Title: "Backpressuring Using A Serial Bus Interface And A Status Switch Cell"

Atty. Doc. No.: AZA-003-7D/2001-P010

#### PRELIMINARY AMENDMENT

FIG. 52

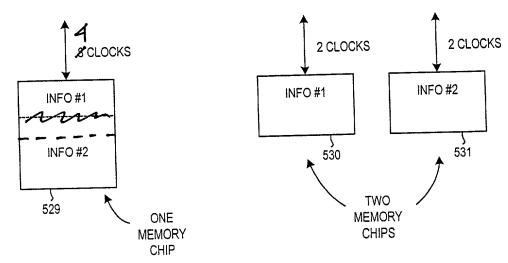
A minor error in Figure 52 is corrected. A copy of Figure 52 with the correction indicated in red is attached. In reviewing the correction, the Examiner's attention is direct to page 59, line 22 of the specification through page 60, line 21 and the corrections made to that text (see below). Review and approval of the correction by the Examiner is requested. No subject matter is added by the correction, nor is it the intent of Applicants or the undersigned that any subject matter be added.

A copy of Figure 52 with the corrections indicated in red is attached.

[eight] <u>four</u> clock periods. In the example to the left of Figure 52, each piece of information can be accessed in two clock periods. Both pieces of information are stored in the same external memory device requiring one to be accessed before the other. A total of four clock periods is therefore required to access both pieces of information.
